TRUCK, UTILITY, LIGHTWEIGHT, MC2 LAND ROVER 110 - ALL TYPES

REPLACEMENT OF THE MAPLIGHT SECURING CLIP
AND SECURING OF THE MAPLIGHT WIRING

MODIFICATION INSTRUCTION

FIG 1 - DIMENSIONS MAPLIGHT CLIP

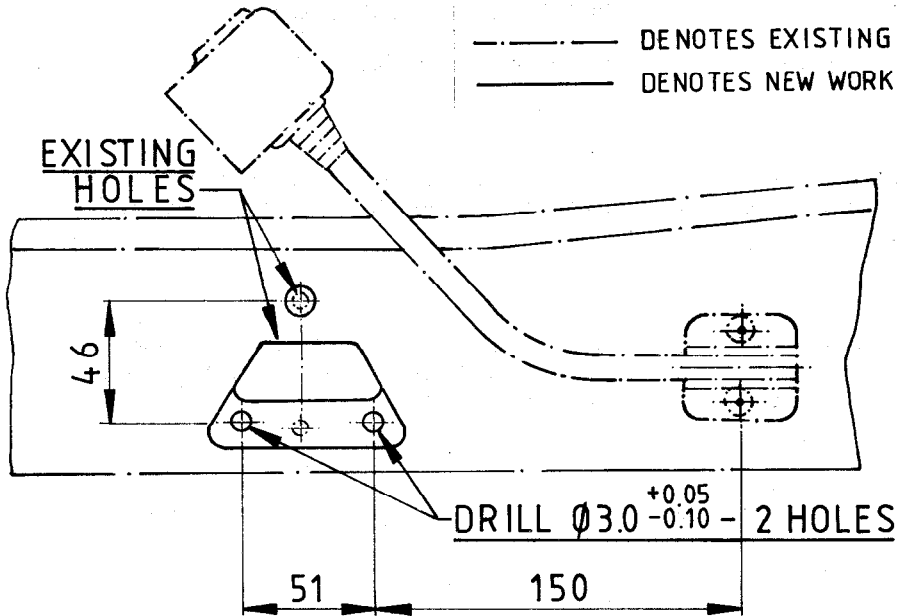
- b. Mark and drill the two holes on the front of the parcel tray to the dimensions shown in Fig 1.

FIG 2 - MAPLIGHT WIRING

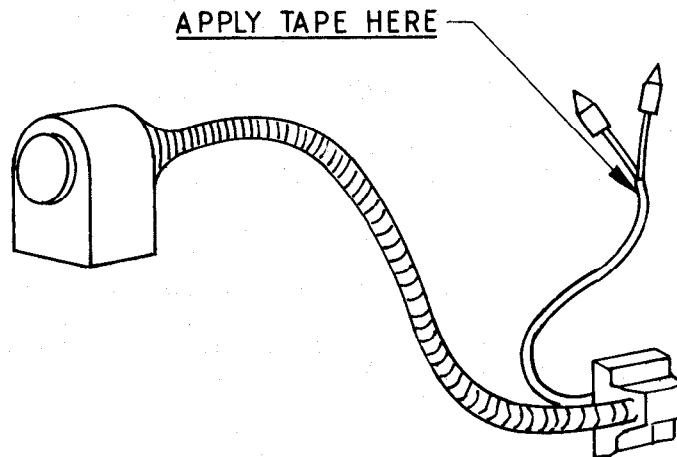
- c. Fit the new clip (item 1 from Table 1) using the original mounting screws and plug the existing hole with a screw (item 2 from Table 1).
- d. Ensure that a sleeve is fitted over the maplight wiring, see Fig 2, and that the sleeve is located in the hole in the dash.
- e. If the sleeve is located in the dash then apply insulation tape at the point shown in Fig 2.

- g. Remove the maplight securing screws and the maplight, and inspect the maplight wiring for chafing.
 - h. If chafing is evident repair the wiring and fit the sleeve (item 3 from Table 1) over and secure as shown in Fig 2.
 - i. Reconnect the maplight wiring and refit the maplight to the dash.
 - j. Reconnect the battery and test the operation of the maplight.
8. Modification Record Plate. Deface the numeral 11 on the modification plate located on the drivers seat base.
9. Recording. Enter the details of the modification in Part Three of the TGM 120, Record Book for Service Equipment, of the subject vehicles.
